HISTORIC AND DESIGN REVIEW COMMISSION

June 20, 2018

HDRC CASE NO: 2018-283
COMMON NAME: 714 SHERMAN
LEGAL DESCRIPTION: NCB 1301 BLK 2 LOT 4
ZONING: R-5, H
CITY COUNCIL DIST.: 2
DISTRICT: Dignowity Hill Historic District
APPLICANT: Tred Trautner/Max Developers Inc
OWNER: James Deng/DBO Investments LLC
TYPE OF WORK: Construction of 300 sq ft primary structure
APPLICATION RECEIVED: June 01, 2018
60-DAY REVIEW: August 01, 2018
REQUEST:

The applicant is requesting a Certificate of Appropriateness for approval to construct a 300 square foot primary structure at 714 Sherman, including a concrete driveway.

714 SHERMAN
SITE PLAN

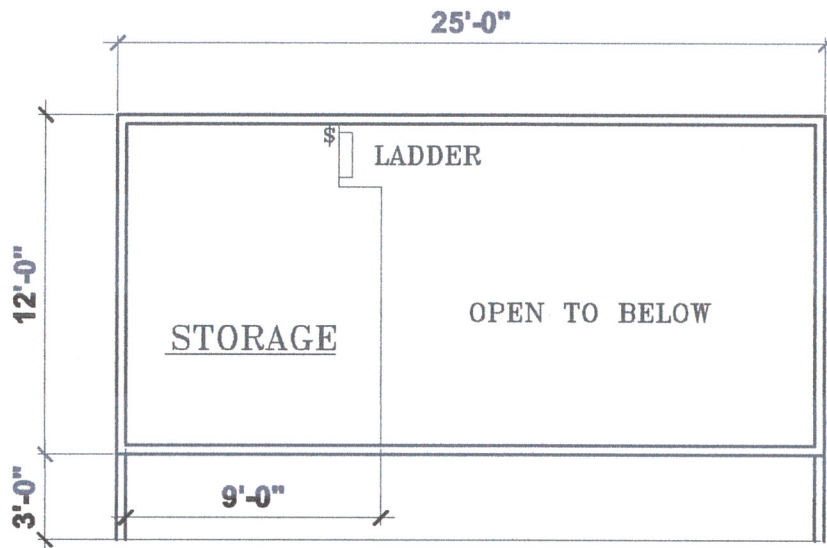
- iv. A measured and developed site plan with landscape details should be submitted for final approval.
- c. SETBACKS & ORIENTATION – According to the Guidelines for New Construction, the front facades of new buildings are to align with front facades of adjacent buildings where a consistent setback has been established along the street frontage. Additionally, the orientation of new construction should be consistent with the historic examples found on the block. The applicant has provided a setback that is consistent with the neighboring properties on each side of the lot. Additionally, the applicant provided a site plan that indicates that the driveway will enter the right side of the lot, adjacent to the off-centered proposed structure. While staff finds that the orientation generally appropriate for full size Folk Victorian or Craftsman structures within the historic district, an orientation condition that relates to the two adjacent shotgun houses would be more appropriate for the thin lot and efforts to reduce square footage of new construction.

- m. **SITE ELEMENTS** – The applicant has not provided measured drawings or a site plan for landscaping and site elements with the exception of the proposed driveway and front walkway. Staff finds those two site elements generally appropriate. However, the applicant should submit a detailed landscaping plan as well as a site plan that notes an appropriate driveway and walkway configuration, width, and location for final approval.

- i. The front-facing gable should so be located above the primary door. The applicant may relocate the gable or the door.
- ii. The two square picture windows should be modified to feature a sash window that are consistent with the Guidelines and compatible to the historic district.
- iii. The porch should feature a depth of at least five feet.
- iv. The applicant must submit a detailed landscaping plan as well as a site plan that notes an appropriate driveway and walkway configuration, width, and location.

RIGHT SIDE ELEVATION

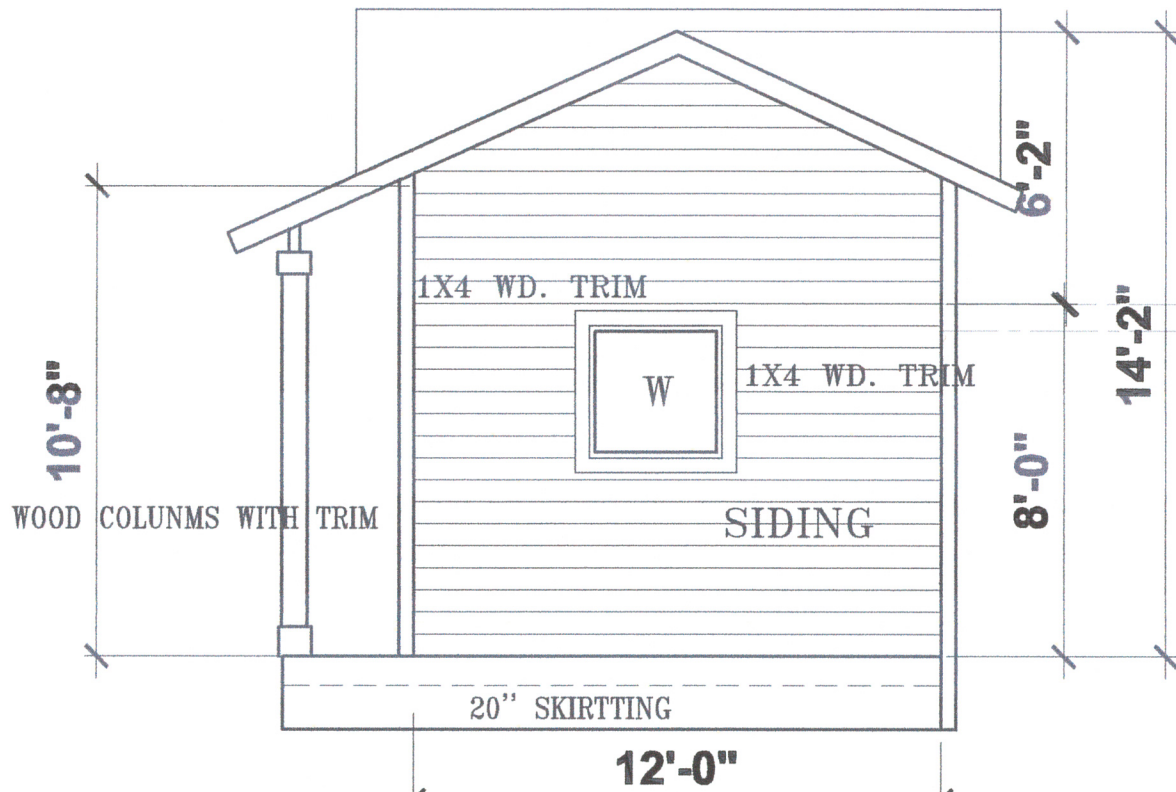
- g. ROOF FORM – The applicant has proposed a roof form featuring a primary gabled roof with a crossed gable and a shed roof over the porch. Historic structures within the district feature hipped or gabled roofs. Staff finds the proposed roof form to be generally consistent with the pattern of this block and the Dignowity Hill Historic District for primary residential properties. However, staff finds that the crossed gable over the left side of the porch featuring an off-centered window and no door is an inappropriate feature not found on historic structures within the Dignowity Hill Historic District. Staff finds that crossed gable should be located above the front door, whether that requires relocating the front door or gable. If the applicant pursues the shotgun house configuration noted in finding c, then the roof should feature a front-face gable with a shed roof over the front porch.

- h. WINDOW & DOOR OPENINGS – Per the Guidelines for New Construction 2.C.i., window and door openings with similar proportions of wall to window space as typical with nearby historic facades should be incorporated into new construction. The proposed design features a total of three (3) one-over-one wood windows, one (1) sliding window, and two (2) square picture windows. Staff finds the one-over-one and sliding windows appropriate, while the two square picture windows should be modified to feature sash windows.
